PRODUCT/PROCESS CHANGE NOTICE (PCN)

PCN #: **A0705-01** DATE: **6/11/2007**

Product Affected: Ceramic DIP, Sidebrazed and Topbrazed of
28 leads or more
(Refer to Att. II for affected part numbers)

ATTACHMENT I - PCN #: A0705-01

Figure 1: Existing material - Silicon bump

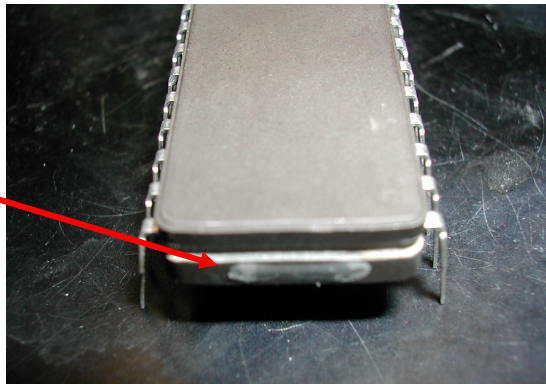
Detail Of Change: This notification is to advise our customers that there will be a change of material from silicon bump to bumper tape, which is applied at the package end (opposite pin 1) to prevent package crack or chip as a result of knocking between units.

Description	Existing Material	New Material
Material	Silicon bump	Bumper tape

Figure 2: New material - Bumper tape
